# Torad

## 900cc

PrintArea

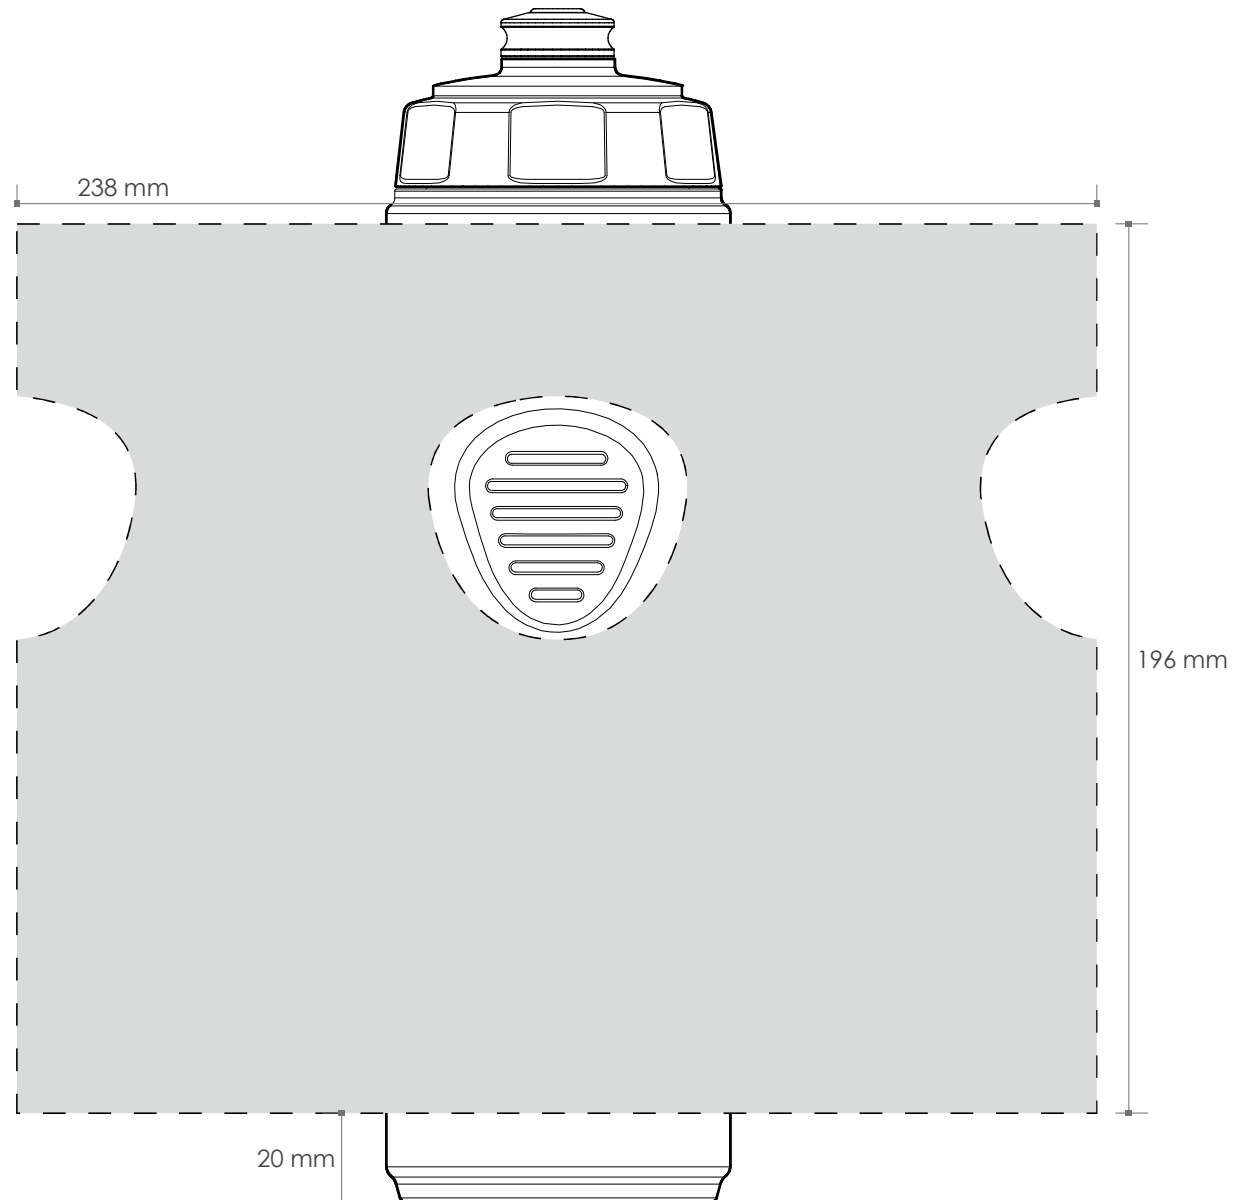
The impression can not close on the circumference of the bottle:  
it's necessary to consider a non-printable area (approx. 0,8 cm width)
